Engineering Change Notice (T-55265GD057J-LW-ADN)

2022/8/2
KYOCERA Corporation
Corporate Display Group
Display Engineering Division
Product Engineering Department

1 . Applicable Product T-55265GD057J-LW-ADN

New product outline dimensions

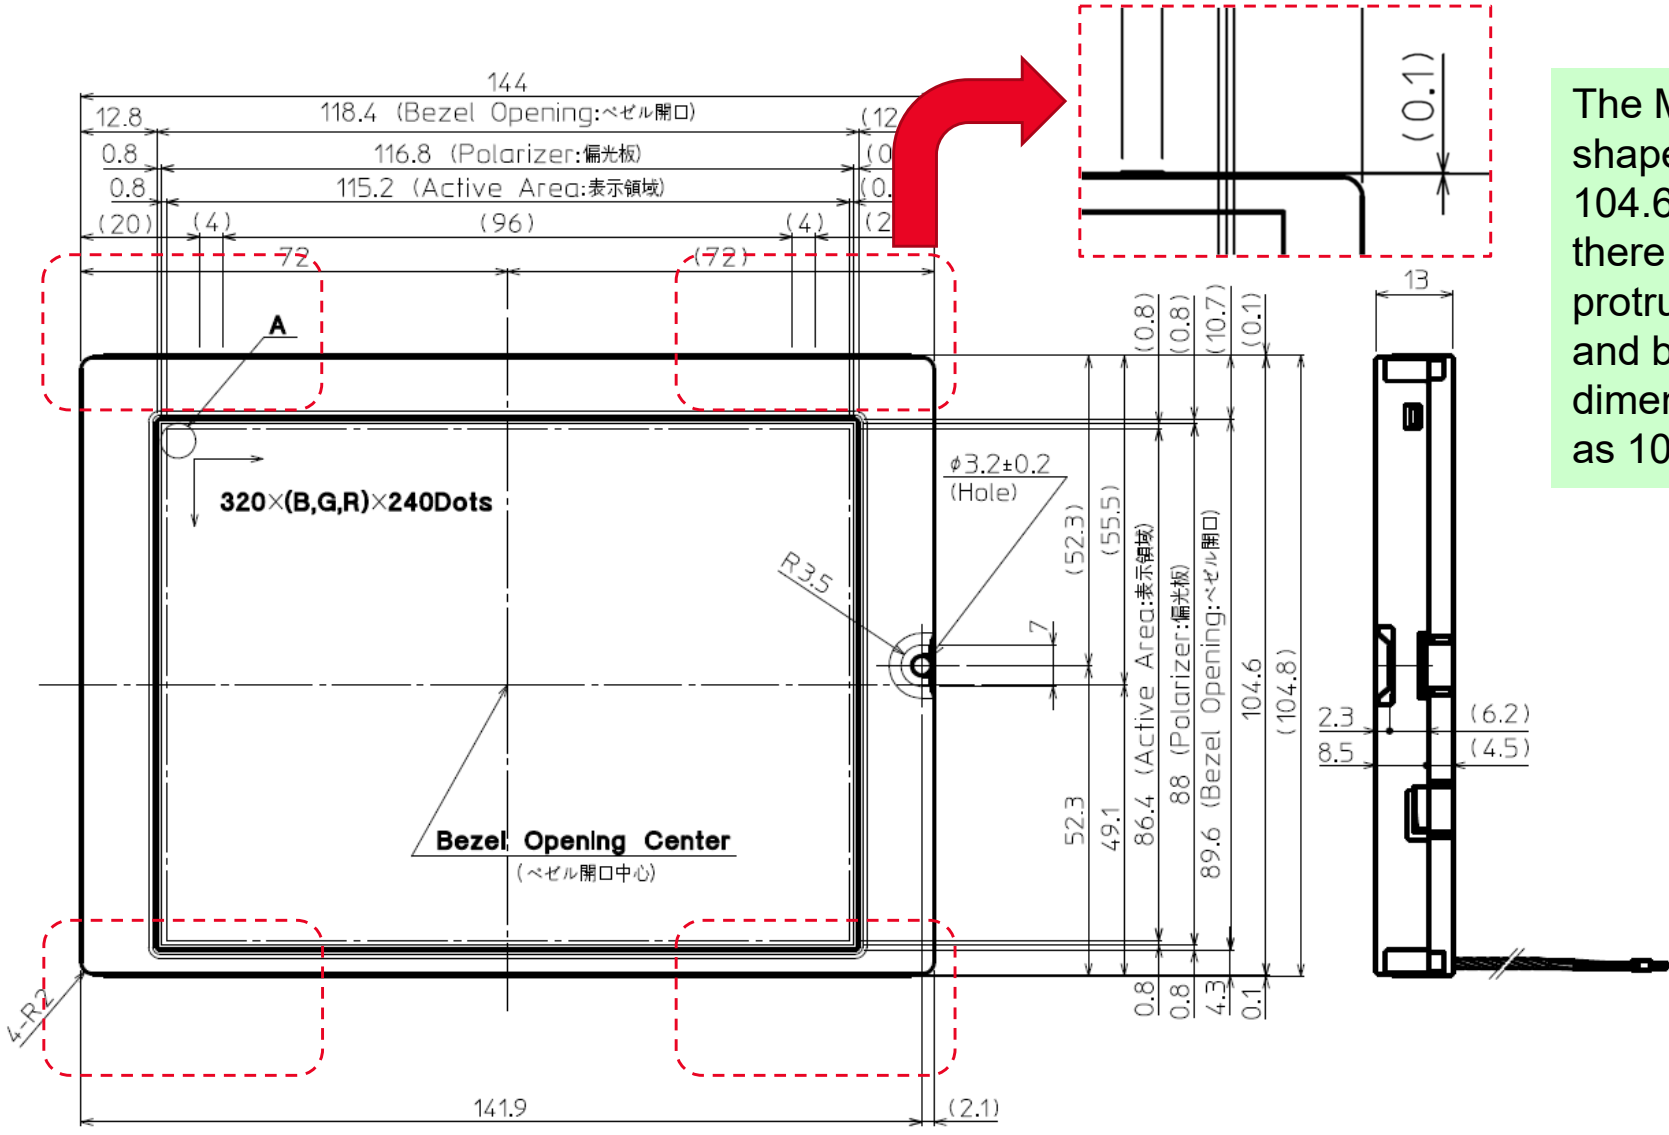
The MDL has an outer shape of 144.0mm x 104.6mm, but since there are four 0.1mm protrusions on the top and bottom, the height dimension is described as 104.8mm.

T-55265GD057J-LW-ADN [Current product]

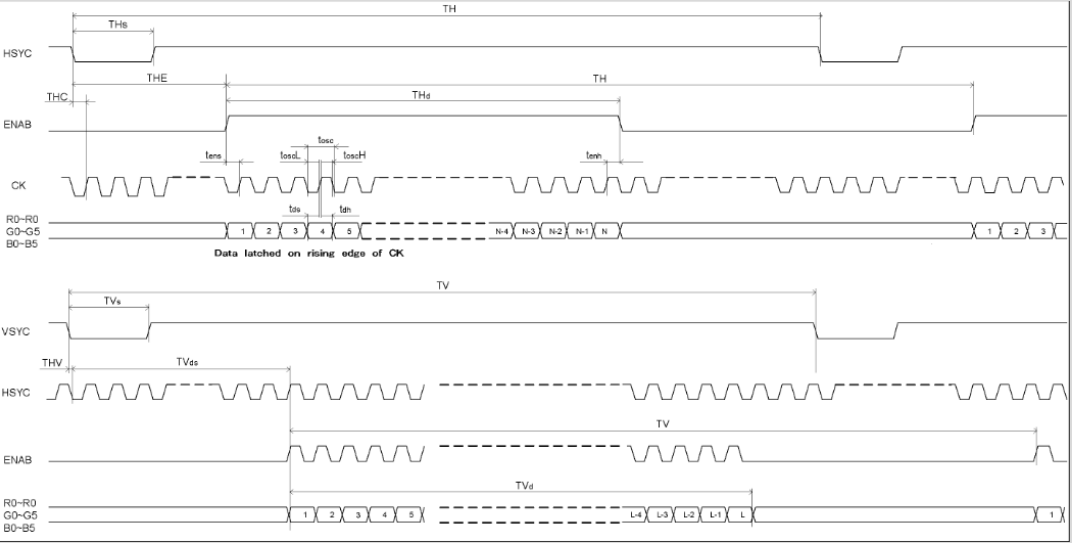
AC Characteristic

Parameter	Symbol	Min.	Typ.	Max.	Units
CK Frequency	1/tosc	-	6.4	-	MHz
CK Period	tosc	-	156	-	ns
CK High Pulse Width Time	toscH	12	-	-	ns
CK Low Pulse Width Time	toscL	12	-	-	ns
CK Pulse Duty ratio	toscH/ tosc	-	50	-	%
Data Setup time	t _{ds}	12	-	-	ns
Data Hold time	t _{dh}	12	-	-	ns
HSYC (Horizontal Sync.) Signal Cycle	TH	-	62.8	-	// S
		-	408	450	clk
HSYC Pulse Width	TH _s	5	30	-	clk
Horizontal Display Term	TH _d	-	320	-	clk
ENAB Setup Time	t _{ens}	12	-	-	ns
ENAB Hold Time	t _{enh}	12	-	-	ns
VSYC (Vertical Sync.) Signal Cycle	TV	-	262	350	Line
VSYC Pulse Width	TV _s	1	3	5	Line
Vertical Display Term	TV _d	-	240	-	Line
Vertical Display Start	TV _{ds}	-	18	-	Line
HSYC-ENAB Phase Difference	THE	-	68	-	clk
HSYC-CK Phase Difference	THC	12	-	-	ns
HSYC-VSYC Phase Difference	THV	1	-	-	clk

T-55265GD057J-LW-AMN [New product]

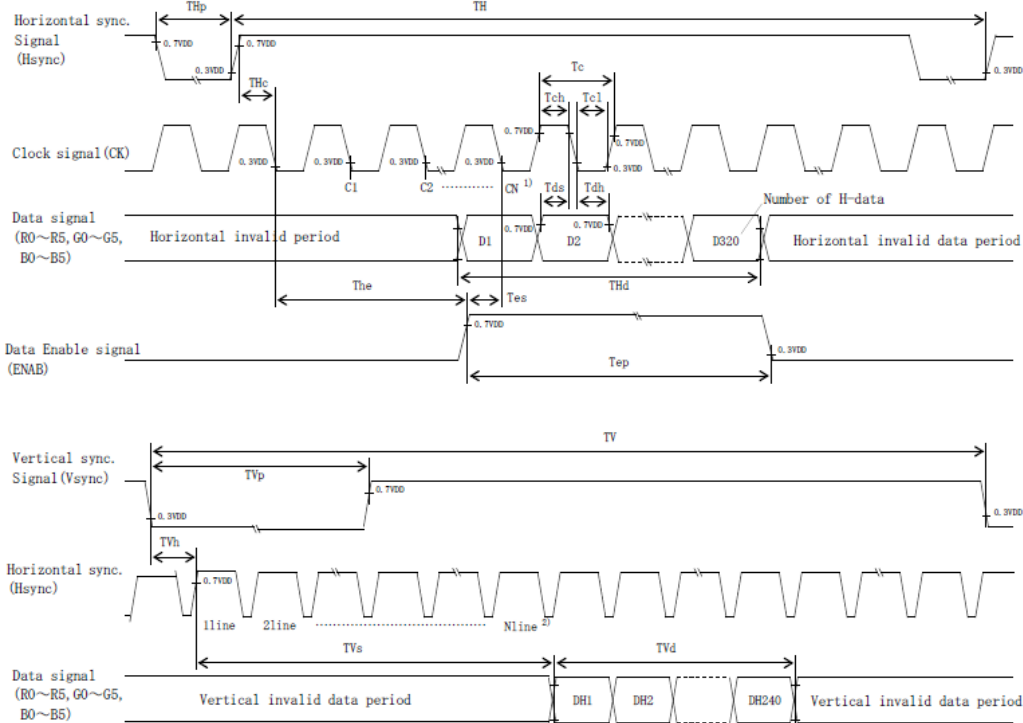
AC Characteristic

Item		Symbol	Min	Typ	Max	Unit
Clock	Frequency	1/Tc	—	6.3	7.0	MHz
	Duty ratio	Tch/Tc	40	50	60	%
Data	Set up time	Tds	5	—	—	ns
	Hold time	Tdh	10	—	—	ns
Horizontal sync. signal	Cycle	TH	50.0	63.6	—	μ s
	Pulse width		THp	2	96	200
Vertical sync. signal	Cycle	TV	251	262	280	line
	Pulse width	TVp	2	—	34	line
Horizontal display period		THd	320			clock
Hsync-Clock phase difference		THc	10	—	Tc-10	ns
Hsync-Vsync. phase difference		TVh	Tc	—	TH-THp	ns
Vertical sync. signal start position		TVs	7			line
Vertical display period		TVd	240			line
Item		Symbol	Min	Typ	Max	Unit
Enable signal	Set up time	Tes	5	—	Tc-10	ns
	Pulse width	Tep	2	320	TH-10	clock
Hsync - Enable signal phase difference		The	2	—	TH-340	clock
